VT-27 Comfort

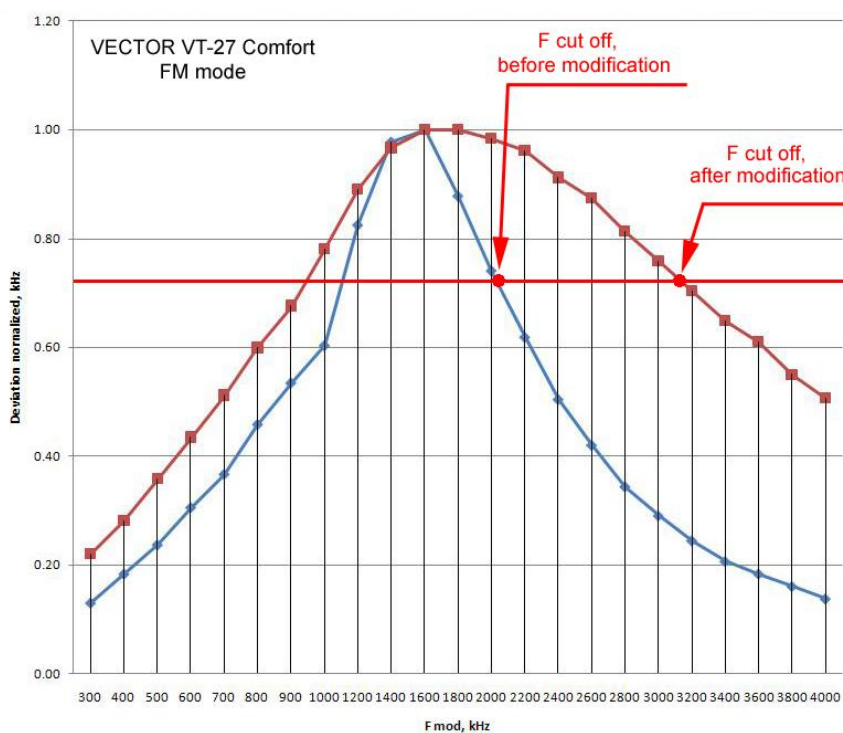
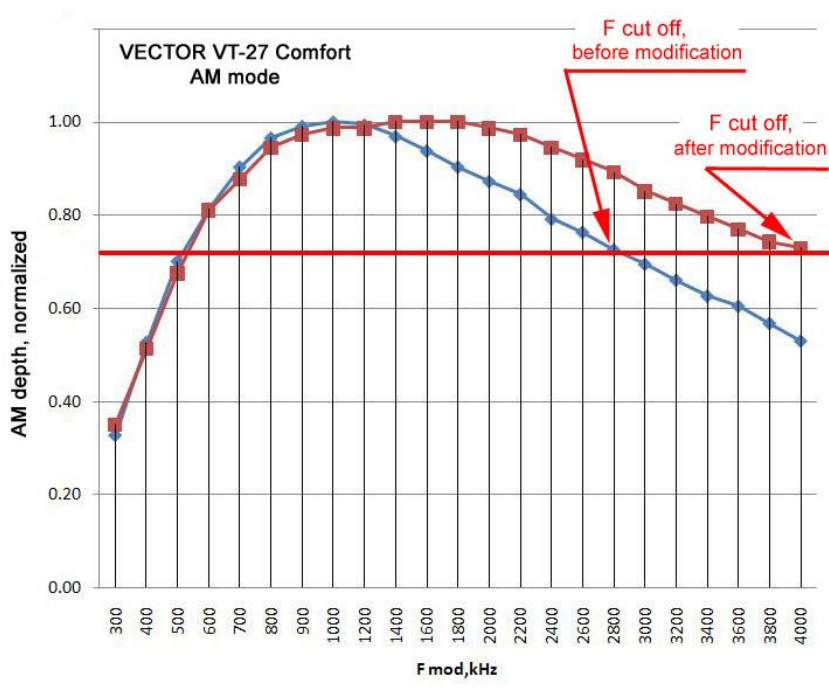
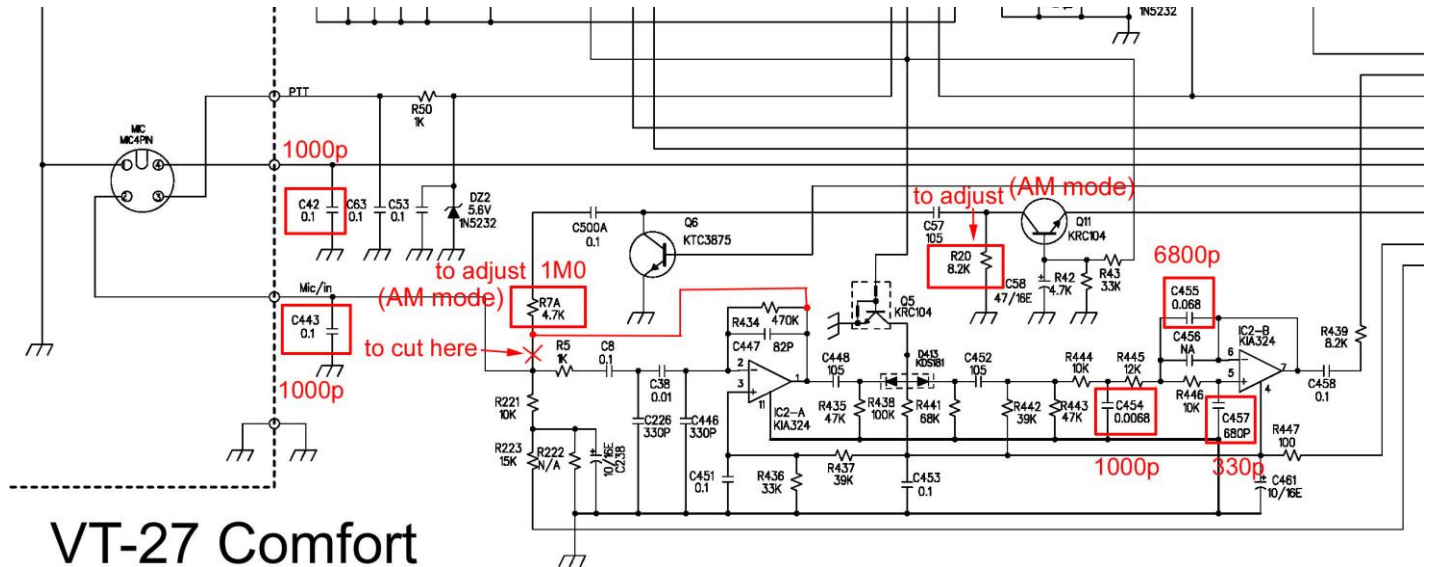
The audio frequency response and sensitivity of mic. input of VT-27 Comfort is no good for our conditions. Audibility (readability) of speech in the air is poor (on FM mode and AM mode also). Cut off frequency of AM/FM modulators is very low. It is necessary to increase up to 3.0-3.5 kHz.

1. To reduce C42 to 1000pF,
2. To reduce C443 to 1000pF,
3. To reduce C454 to 1000 pF,
4. To reduce C455 to 6800 pF,
5. To reduce C457 to 330 pF.
6. To increase R7A to approx. 1 MΩ and to adjust it (at AM mode only).
7. To connect lower lead of R7A to out of IC2-A (pin 1) (see diagram above),
8. To adjust R20 (when required).
